September 14, 2017

SUBJECT: Review of Final Environmental Impact Report for the Proposed Crystal Geyser Bottling Plant Project in Siskiyou County - Transportation and Traffic Comments

Mt. Shasta Boulevard Photos – September 14, 2017 Comment Letter P28

Southbound Mt. Shasta Boulevard Just South of I-5 at Beginning of Bike Lane

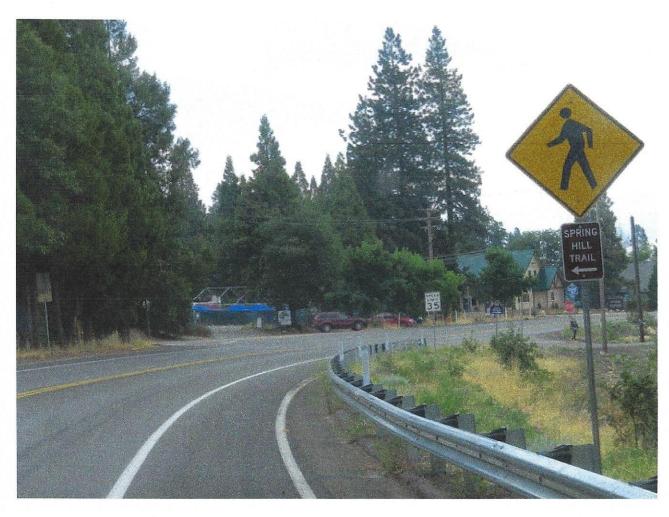
- c) Necessary Further Action The enclosed photos show southbound Mt. Shasta Boulevard from the I-5 Freeway to Mt. Shasta City Park. These photos show the existing bicycle lane and the roadway curvature. A pedestrian crossing warning sign is posted for approaching motorists but the effectiveness of this sign alone is not known. No consideration has been given to the safety of pedestrians and bicyclists with increased Project truck traffic. No data regarding pedestrian volumes, bicycle volumes, and collision histories has been provided. Without any data or analyses, the FEIR concludes there will be no impacts associated with the additional truck traffic generated by the proposed project. Data for existing conditions plus further analyses of conditions with Project truck traffic is required to support the conclusion there will be no impacts on pedestrian and bicycle traffic and that no mitigation measures are needed.
